**PLANNING COMMISSION
MEETING AGENDA
SPECIAL/STUDY MEETING**

SUBJECT: PRELIMINARY SITE PLAN REVIEW – Proposed Cedar Pines Woods Site Condominium, 8 units/lots, East side of Crooks, South of Benjamin (6622 Crooks), Section 4, Currently Zoned R-1B (One Family Residential) District

PRELIMINARY SITE PLAN REVIEW – Proposed Cedar Pines Woods Site Condominium, 8 units/lots, East side of Crooks, South of Benjamin (6622 Crooks), Section 4, Currently Zoned R-1B (One Family Residential) District

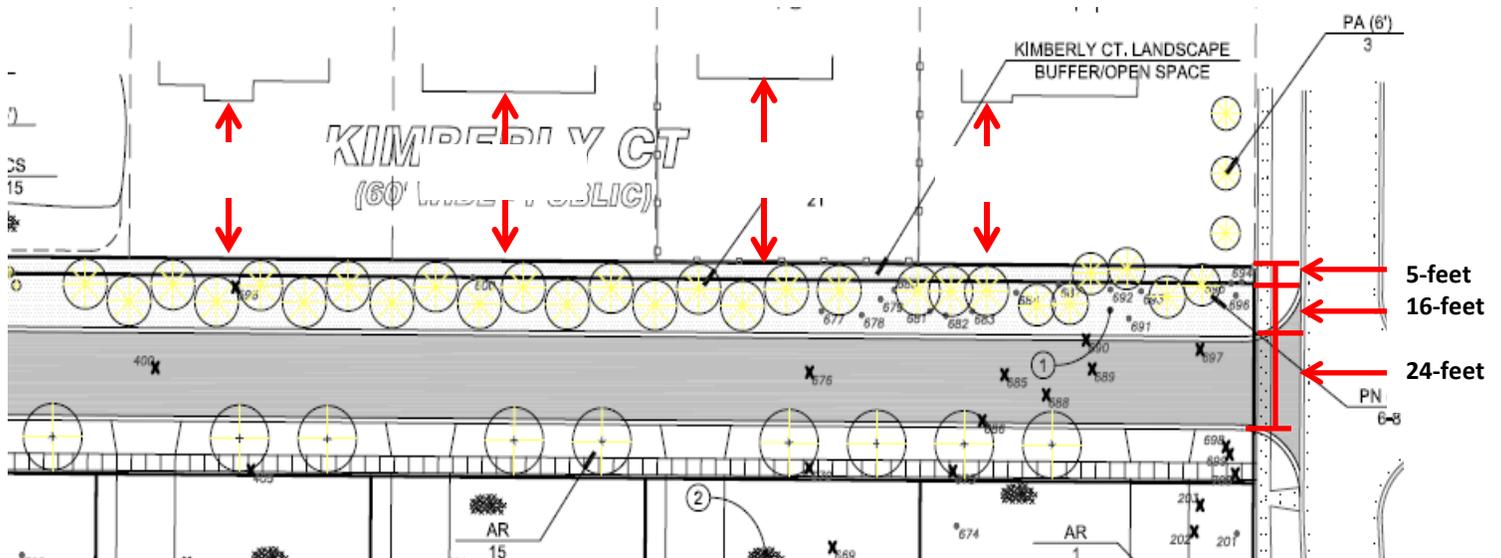
The proposed site condominium consists of 8-units. Lot 8, which is created to maintain the existing house on site, is approximately twice as large as the other seven (7) lots. The other seven (7) lots range in size between 13,500 square feet and 18,500 square feet.

Lots 1-7 are accessed off a single loaded cul-de-sac. The right-of-way to the created cul-de sac is five (5) feet from the rear property line of four (4) houses that front on Benjamin Drive. The edge of road pavement is approximately 21-feet from the rear property line of four (4) houses that front on Benjamin Drive. The applicant proposes to plant the 5-foot and 16-foot (21-feet total) buffer with twenty-seven evergreen trees.

The 5-foot wide landscape buffer along the Kimberly Court ROW and the northern property line is not wide enough to provide for significant screening. As a result, the applicant is proposing to plant within the City right-of-way in order to provide a landscape buffer for the adjacent Benjamin Road properties. Evergreen planting with the City right-of-way is not permitted. Due to the road location we understand the need to buffer; however the use of the City ROW as a buffer is not permissible. The buffer must be located on private property or within an easement. If the applicant were to relocate the road, the necessity for such significant buffering to adjacent properties would be negated.

The 5-foot strip between the right-of-way and the northern property line is part of Lot 7. The future owner of Lot 7 is responsible to maintain this 5-foot strip as well as the 16-foot wide area planted with the buffer trees. This area is approximately 550 feet x 21 feet = 11,500 sq/ft.

The setbacks for Lot 6 were incorrectly determined. The applicant shows a side yard along the property line, when this is a rear setback. Based on current configuration, Lot 6 is unbuildable. The applicant will either need to remove Lot 6 or reconfigure the site plan.

Items to be addressed: 1). Reconfigure lot six building or reconfigure site plan; and 2). Identify maximum lot coverage

CEDAR PINES WOODS
PRELIMINARY SITE PLAN
CITY OF TROY
OAKLAND COUNTY, MICHIGAN
PRELIMINARY GRADING PLAN

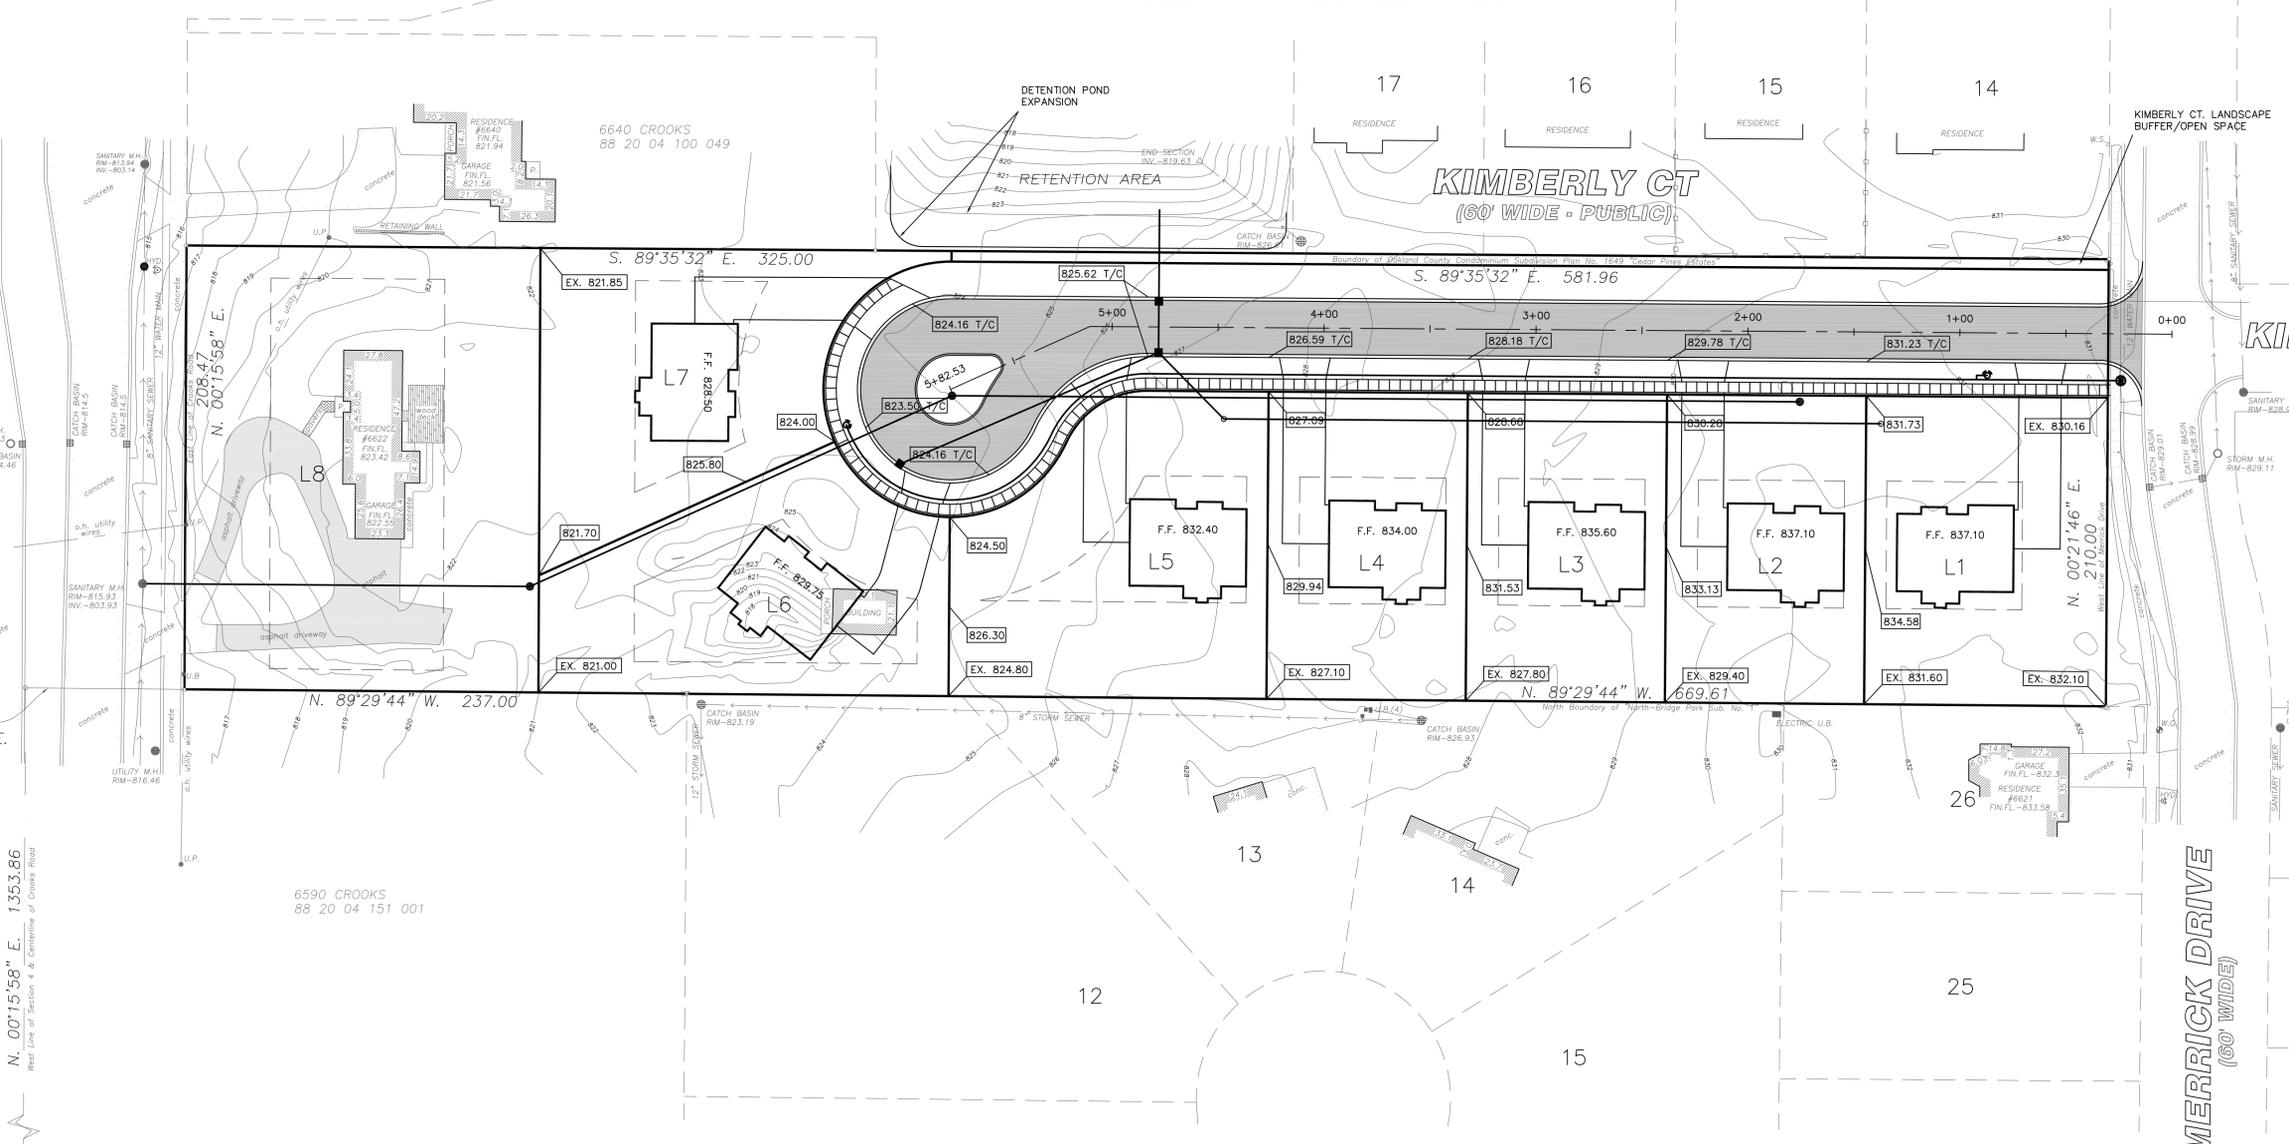
| | <u>Required:</u> | <u>Provided:</u> | <u>Compliance:</u> |
|---------------------------------------|--|--|---------------------------------|
| Lot Size per Unit* | 15,000 square feet (for projects with sewer) | 13,574 square feet is the smallest as indicated by applicant; however the setbacks for Lot Six were incorrectly determined. Based on revised setbacks, Lot Six does not comply. | Does not Comply |

**CEDAR PINES WOODS
PRELIMINARY SITE PLAN
CITY OF TROY
OAKLAND COUNTY, MICHIGAN
PRELIMINARY LANDSCAPE AND
TREE PRESERVATION PLAN**

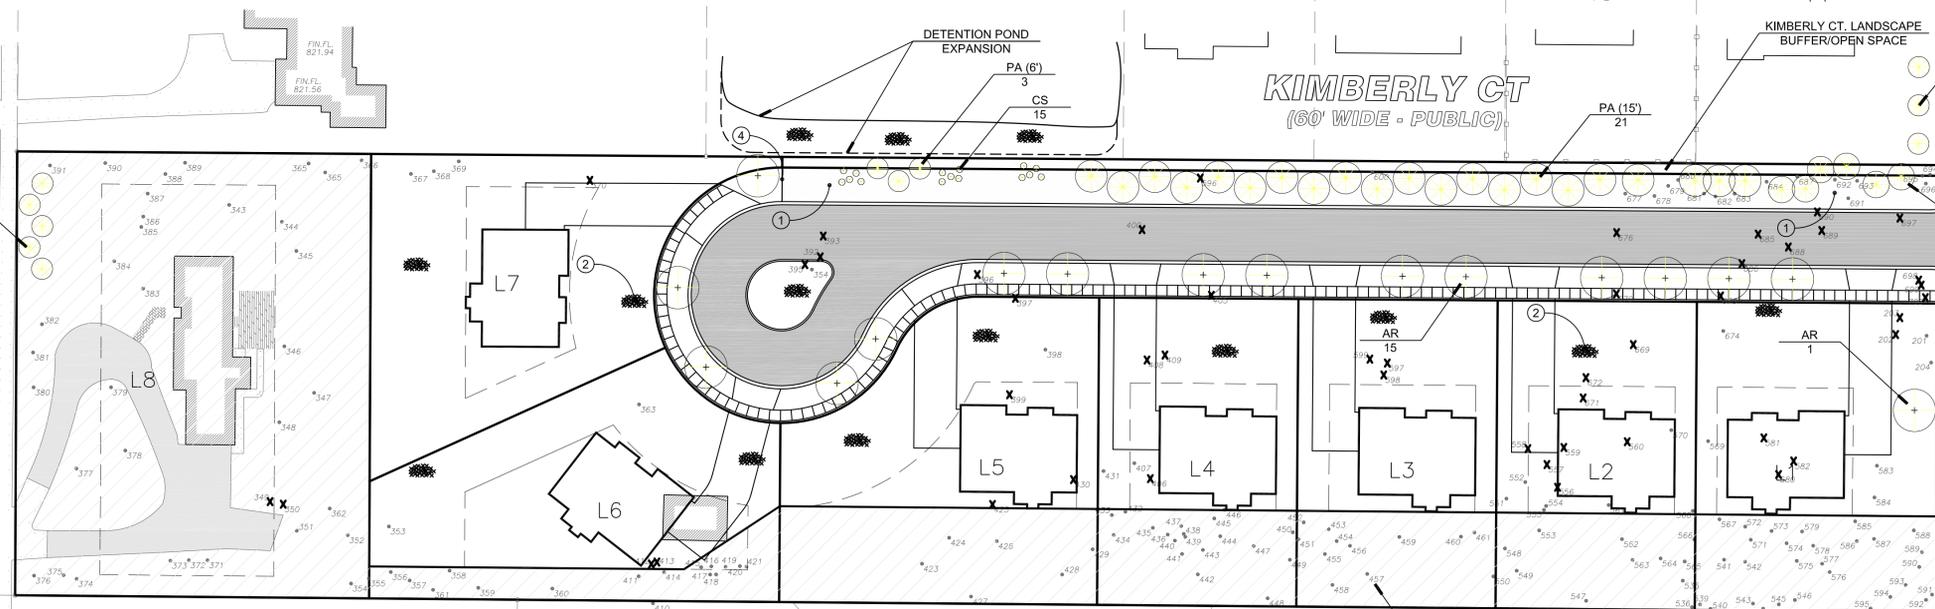
Woodlands – The topographic plan and aerial images indicate heavily wooded areas on the central and western portions of the site. The applicant intends to create a tree protection area adjacent to the southern edge of the site. Several trees are slated for removal to accommodate the development. The

Items to be Addressed: Provide justification for tree removal near northwest corner of site.

Kimberly Court frontage includes proposed evergreen tree screening. As noted above, the proposed landscaping must be modified. The applicant will be required to amend landscape plan accordingly.

Items to be Addressed: Amend landscape plan based on site plan changes.
